**SAN JOAQUIN SOLAR 1 & 2 HYBRID
PROJECT
12-AFC-08**

**Supplemental Information
In Response To Cure Data Request Set #5**

October 5, 2009

CONCEPTUAL ARRANGEMENT
EQUIPMENT SHOWN REPRESENTS
PRELIMINARY LAYOUT AND IS
SUBJECT TO CHANGE UPON FINAL DESIGN

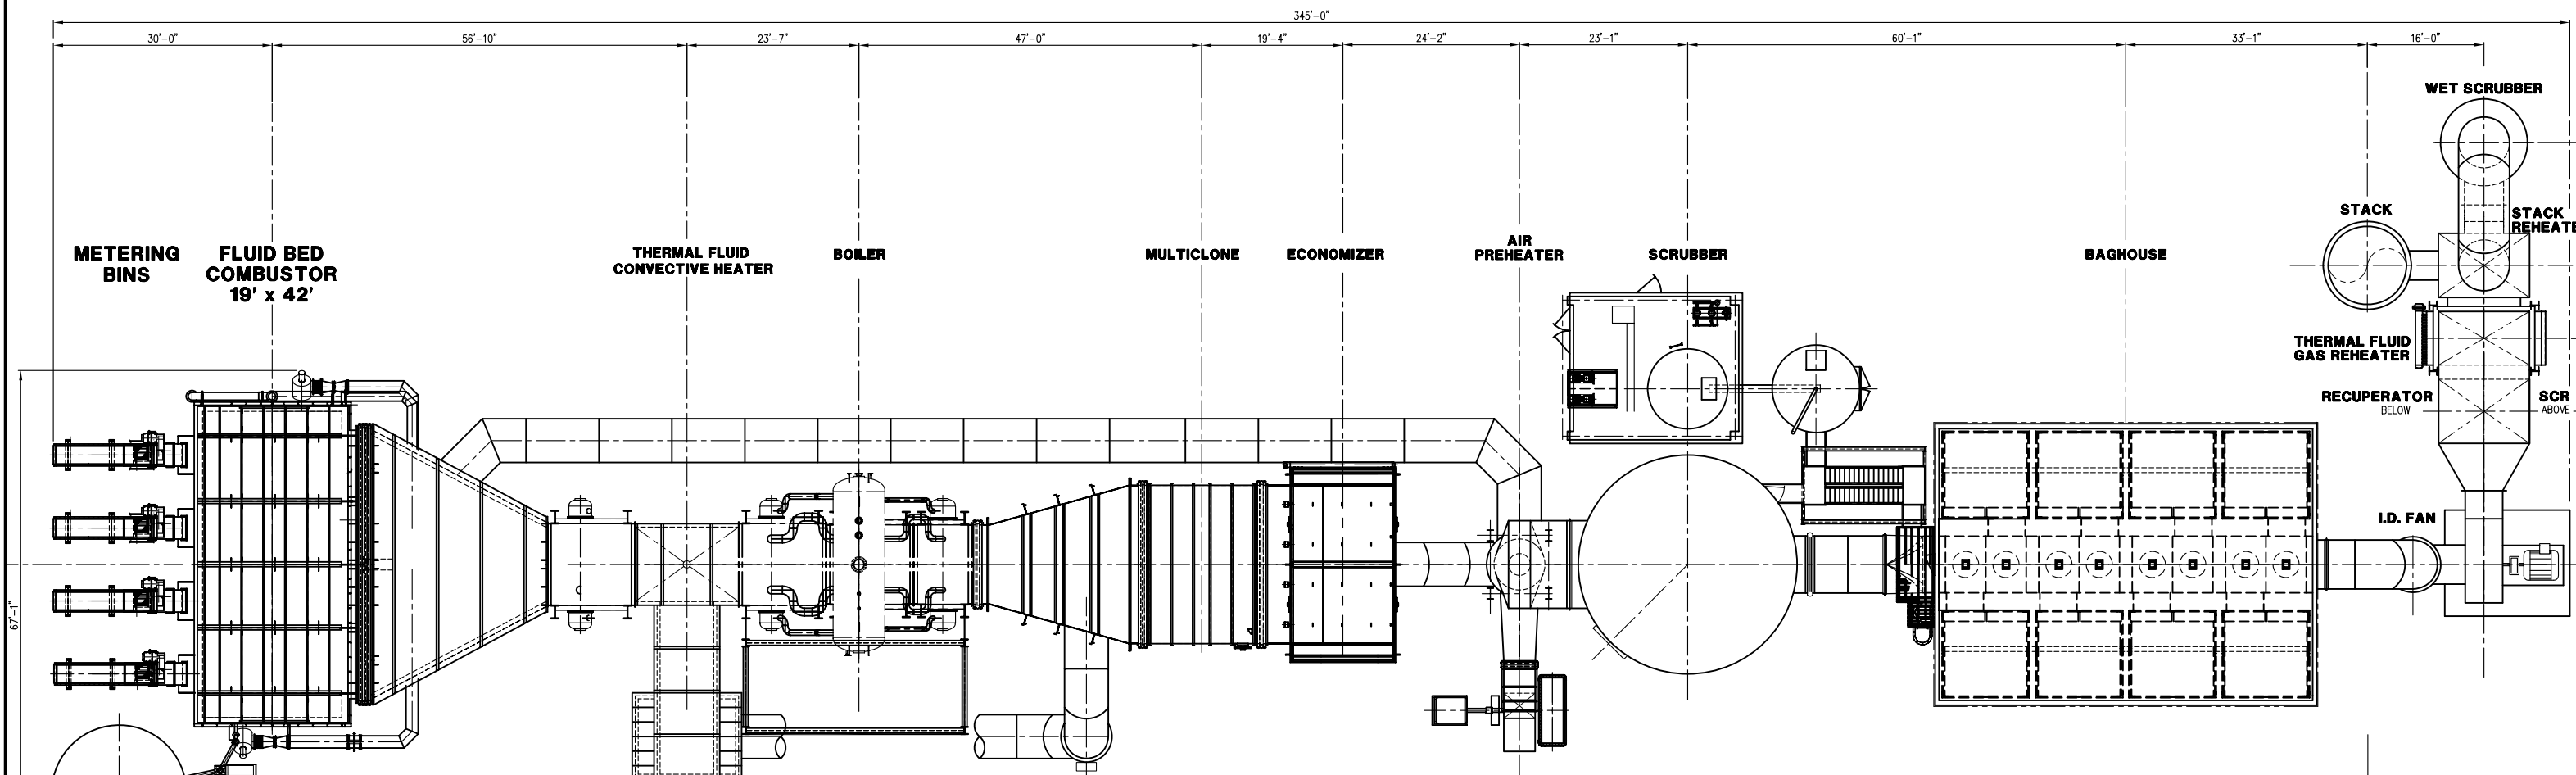
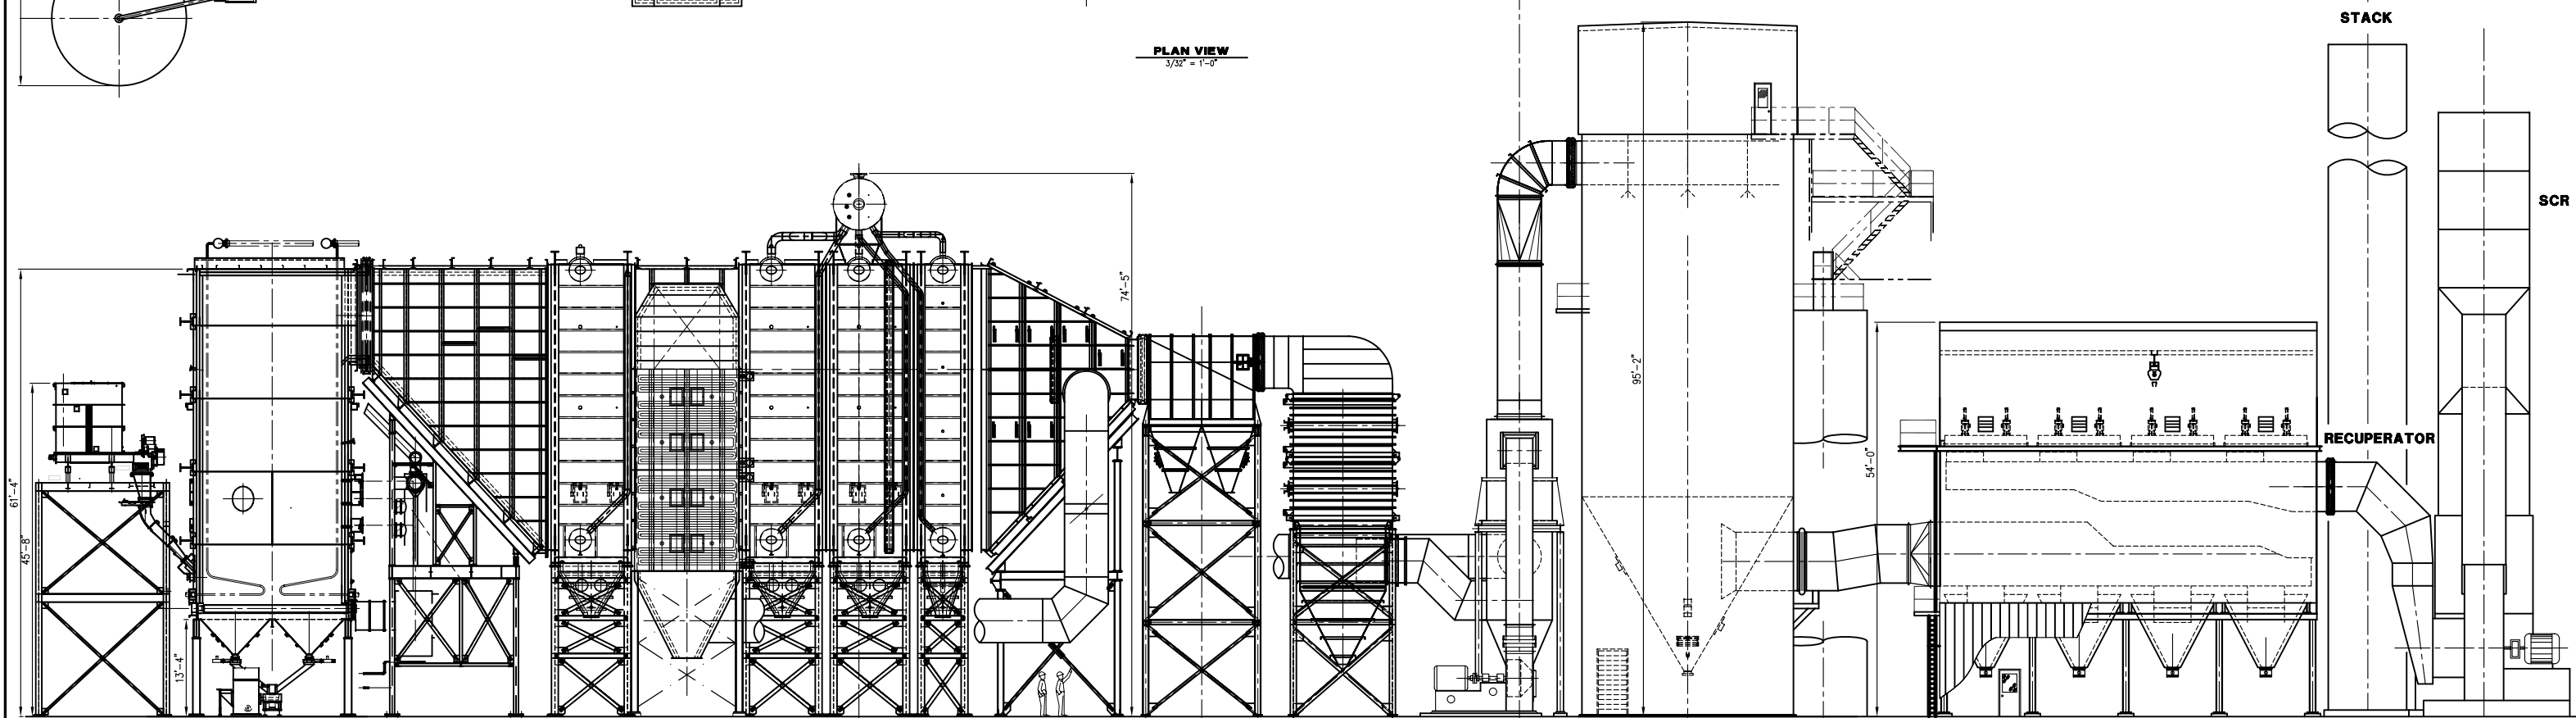
Data Request 206: Please provide EPI vendor specifications for the fluidized bed combustors that will be installed at the Project.

Response: The applicant has provided many specifications for the fluidized bed combustors from EPI. The vendor specifications for the fluidized bed combustors such as equipment dimensions or materials of construction are not finalized but a preliminary general arrangement is shown in the attached figure.
